# SP Garments Ltd. (Extension Building)

31 October 2021

1. Warehouse Building is a five storied (G+4) steel building.

SCHEDULE OF STEEL COLUMN

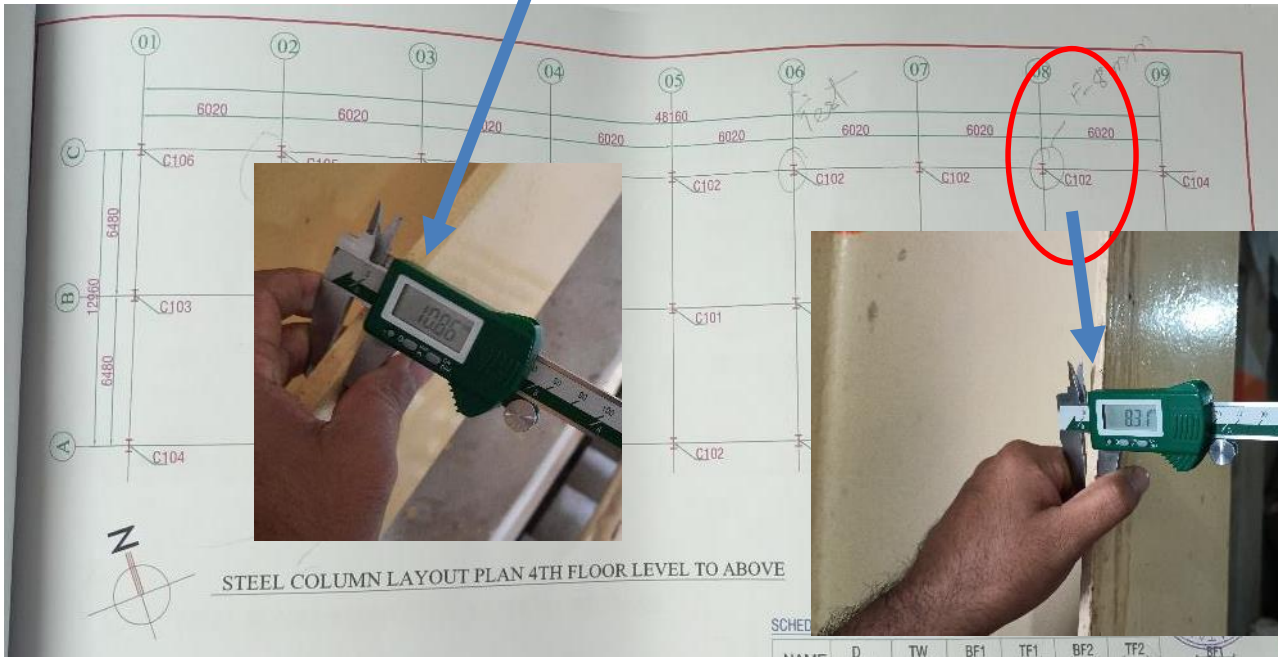
Flange thickness of steel column C-102 at grid 08-C and C-103 at 4<sup>th</sup> floor level were found 8 mm instead of 10 mm and 10 mm instead of 12 mm, respectively.  
 Also, the flange thickness of Main Beam at stair was found 10 mm instead of 12 mm
